QC-FIT EVALUATION OF SHEAVES FAILURES

Office of Offshore
Regulatory Programs

QC-FIT Report #005
May 2017

FIGURE 4: DUAL WEB DESIGN SHEAVE ASSEMBLY - WELD LOCATIONS IN RED (OEM PIB#87819987)

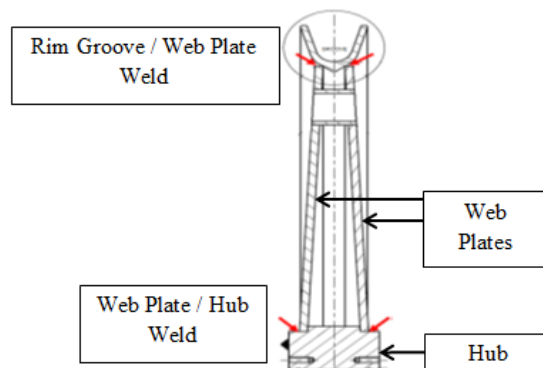
On February 7, 2015, while performing drilling operations off the coast of Colombia on the Bolette Dolphin drilling rig for Ecopetrol-Anadarko, Dolphin Drilling/Fred Olsen Energy identified the first sheave failure and reported to NOV. On March 8, 2015, while conducting maintenance inspections of the CMC, the drilling crew discovered large cracks on the dual web fast line sheaves on the Rowan Resolute drilling rig operating in the GOM. The OEM reported these sheave failures to BSEE. These sheave failures prompted the OEM to initiate an engineering RCA and a third-party metallurgical RCA of the failed sheave. The affected sheaves were dual web design sheaves, see Figure 4.

- The OEM specified a hand weld root pass procedure, followed by an automated SAW technique welding procedure. This procedure did not allow for a full penetration depth of the weld filler metal on the inside of the hub-web weld joint, creating a stress concentration.

Following the RCA results, NOV issued two PIB’s 87819987 (Revisions 0 and 1) (Appendix 2) for all users to visually inspect for cracks on a weekly basis at the hub weld on the 78-inch diameter dual web design sheave and initiated replacement of all the dual web design sheaves with single web design sheaves. The single web design sheave allows welding on both sides of the hub-web weld joint, as opposed to welding only one side for the dual web design sheave. This change results in a more robust weld joint as the weld filler metal will fill the gap of the root of the weld joint.

FIGURE 5: CRACKS IN WELD JOINT AND WEB PLATES INDICATED BY RED ARROWS (OEM PIB#87819987)

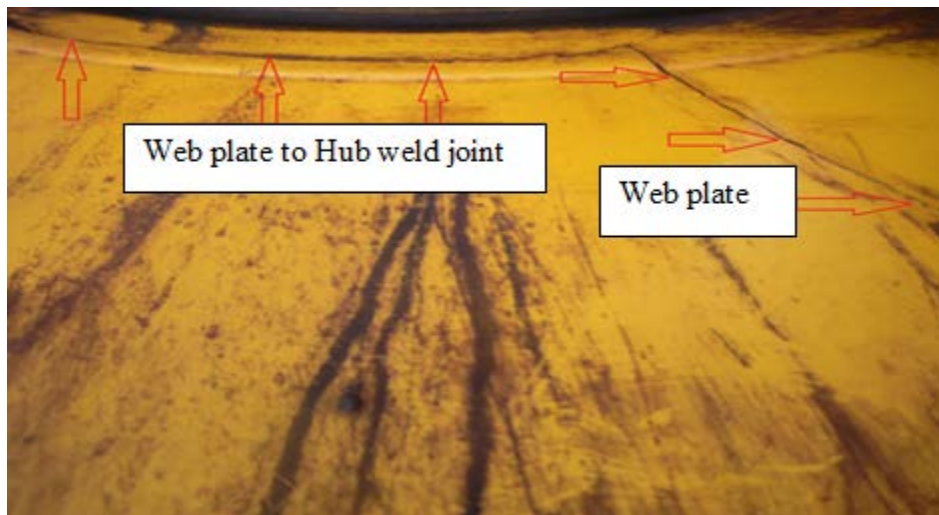
The dual web design sheaves can be interchanged with the single web design sheave. The RCA conducted by the OEM stated that the dual web design sheave prevented weld filler metal from penetrating deep enough to fill the gap on the inside of the hub-web weld joint. Thus, a crack initiated at the gap of the root of the weld and propagated through the weld seam into the web plate (Figures 5 and 6).

- The OEM verified that the sheave failure was due to high nominal stress levels in the sheave hub-web connection in combination with the additional stress concentration caused by the dual web design, which prevented welding of the inside of the hub-web weld joint and resulted in a gap. This stress concentration caused the crack initiation at the gap of the weld, which propagated through the weld into the web plates (Figures 5 and 6).

FIGURE 6: DETAILED CROSS-SECTION OF WEB PLATES TO HUB WELD SECTION CRACK INITIATION AT THE GAP AND PROPOGATION PATH SHOWN BY THE RED ARROW (RCA REPORT)

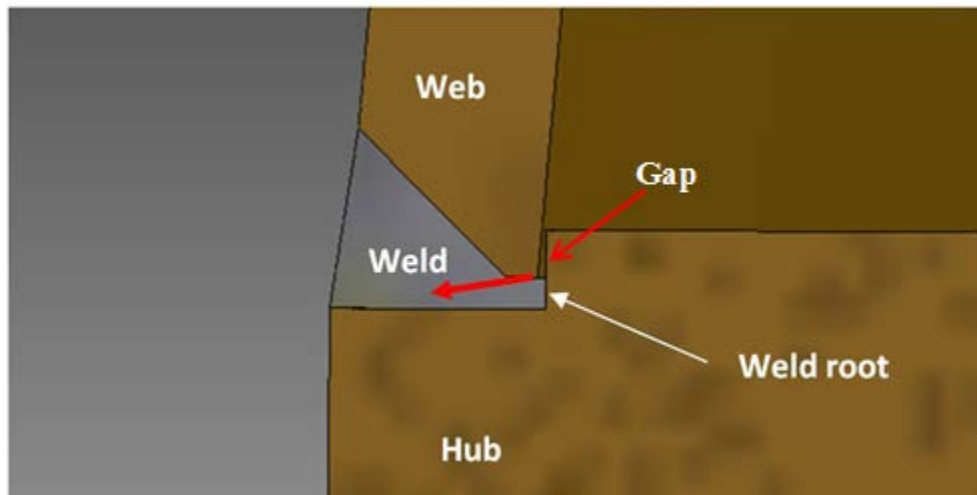
- The Metallurgical RCA investigation attributed the sheaves' failure to the dual web design of the sheave. The dual web design prevented welding on the inside of the web plates to the hub. The OEM specified a manually welded root pass, followed by an automated SAW technique welding procedure. This procedure did not allow for a full penetration depth of the weld filler metal, which resulted in a gap between the inside of the web plate to the hub weld joint. This gap between the inside of the web plate to the hub weld joint allowed for stress concentration and crack initiation at the gap of the root of the weld (Figure 6).

In the case of this evaluation, the OEM’s welding parameters should have specified that sufficient heat be applied to achieve a wider, deeper penetration along the backing surface gap of the root of the weld. This would have enabled the weld to be more resistant to crack initiation.

Illustrations: Above: Example of crack at hub of old fastline sheave. Right: Cross-section of typical sheave. The red arrows are pointing at the welds that supplier defines as "critical".

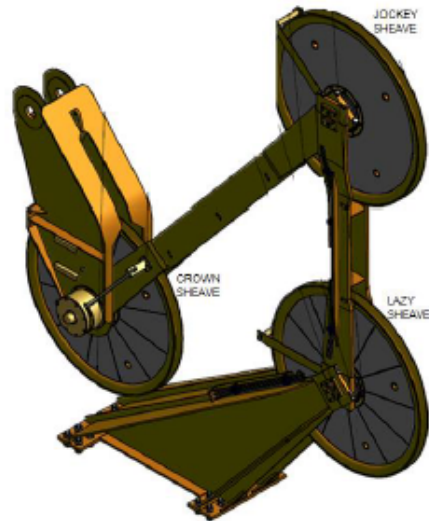
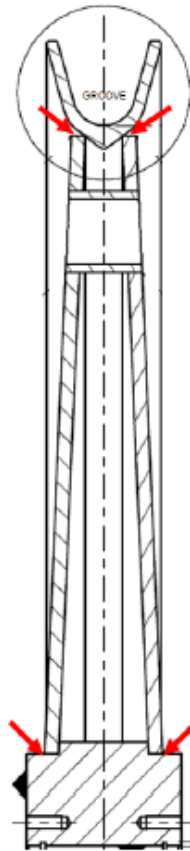
- Issue:** Hub weld cracking incidents have been reported for the CMC's 78" fastline jockey sheave (the middle of the three sheaves in the fastline linkage arm assembly). These cracks propagate from weld defects near the root of the weld between the web plates and the hub.

- Solution:** NOV recommends that the present fastline jockey sheave be replaced with a single-web sheave. Until replacement is performed, the critical welds of the sheaves in the fastline linkage arm assembly should be visually inspected for cracks on a weekly basis. The Critical Welds are shown in the Maintenance Instructions and in the figure below. Additionally, users should ensure that appropriate fastline stabilizers are installed, as these significantly lower the dynamic high-frequency side loading on the sheaves.

Illustrations: Above: Example of crack at hub of old fastline sheave. Right: Cross-section of typical sheave. The red arrows are pointing at the welds that supplier defines as "critical".

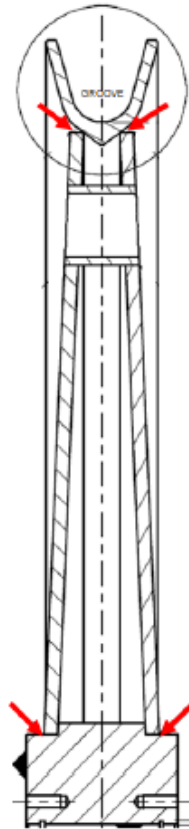
Subject:	Incidents Reported for CMC Wire Sheaves
Product Models:	Crown Mounted Compensator (CMC), CMC-1000-25 / 2500, using 78" wire sheaves with NOV item no. 207785 and 207786.
Affected Assemblies:	Crown block sheave block D1104-A2700, with seven regular sheaves. Fastline and deadline linkage arm assemblies D1104-A4000/A4001/A4002; - each assembly with one regular sheave and two light-weight sheaves.
Objective:	To inform the user about the reported CMC 78" sheave incidents, to stress the importance of frequent sheave inspections according to the Maintenance Instructions, and to recommend replacement of the sheaves. Compared to the previous revision of this bulletin, this revision extends the coverage to include the cluster sheaves in addition to the originally covered jockey sheave position.
Issue:	Hub weld cracking incidents have been reported for the fastline jockey sheave (the middle of the three sheaves in the fastline linkage arm assembly) and among the crown block sheaves. The cracks propagate from weld defects near the root of the weld between the web plates and the hub.

Solution:	NOV recommends that all 78" CMC wire sheaves with item no. 207785 and 207786 be replaced with single-web sheaves. Until replacement is performed, the critical welds of the sheaves should be visually inspected for cracks on a weekly basis. The Critical Welds are shown in the Maintenance Instructions and in the figure below. Additionally, users should ensure that appropriate fastline stabilizers are installed, as these significantly lower the dynamic high-frequency side loading on the sheaves.
